Norfolk Southern Railway Company
Pittsburgh Vertical Clearance Projects/W. North Avenue and AC Pedestrian Bridge
Design Advisory Technical Team Meetings - September 14, 2023, and October 23, 2023
Responses to Comments

AC PARK PEDESTRIAN BRIDGE
OPTION 5A

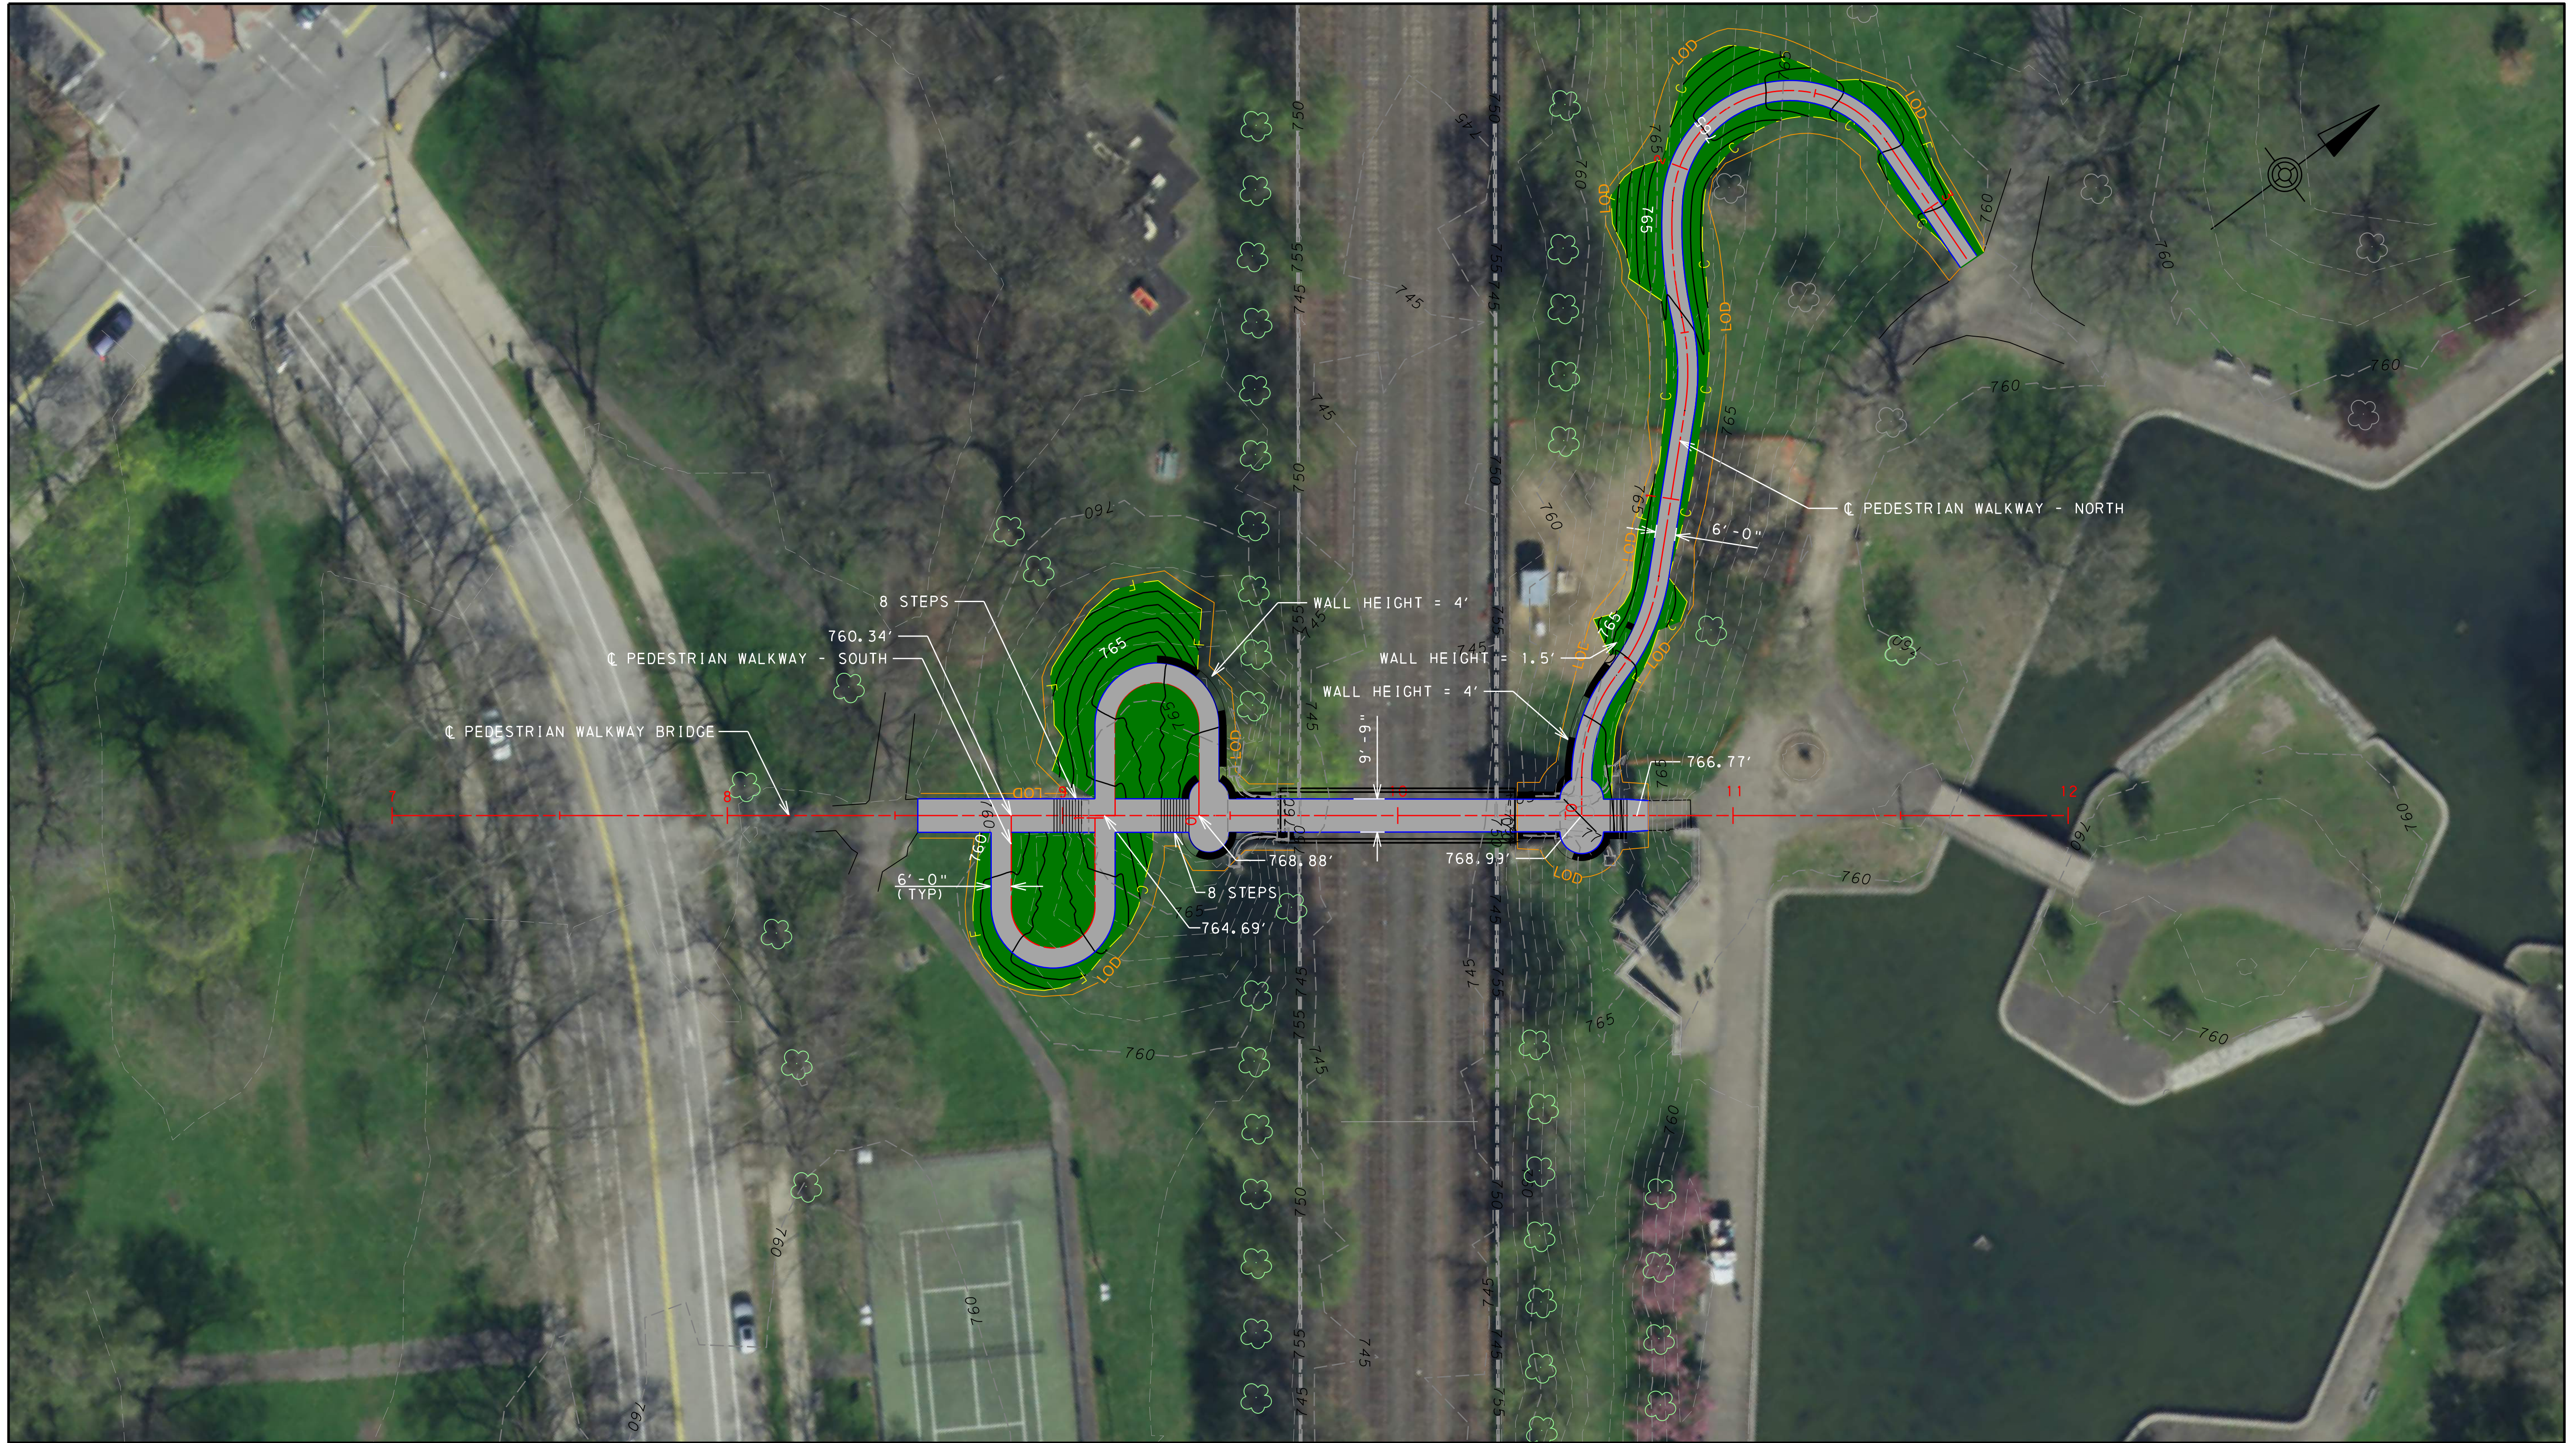
2	12/15/2023 PA SHPO Comments on Ped Bridge Design/ Page 1/ AC Pedestrian Bridge/ Paragraph 5	Emma Diehl/ Barbara Frederick	As the 60% design process approaches, we would appreciate the development of renderings of the new Allegheny Commons bridge, especially the approach plazas being designed as part of Option 5a.	Renderings will be prepared for and provided prior to DAT Meeting #3.
3	12/15/2023 Rick Belloli, Q Development email/AC Pedestrian Bridge/Bullet 1	Community DAT Technical Team *	We would like confirmation that all the walkways are <5% grade, ensuring that they are both ADA accessible and that they will not require any railings or occasional landings as a result.	The paths proposed with the latest concept (Option 5A) are all ADA accessible (5% grade maximum) with only landings at the stair intersections. Railings are proposed on the retaining walls.
4	12/15/2023 Rick Belloli, Q Development email/AC Pedestrian Bridge/Bullet 2	Community DAT Technical Team *	Where there are retaining walls in the plan, we would like more clarification on the proposed materials, design elements, and landscaping plans around said walls.	As we progress the design to the 60% design level, we will have a better understanding of the limits and height of the proposed retaining walls. These types of details (proposed materials, design elements, and landscaping plans) will be discussed at DAT Meeting #3.
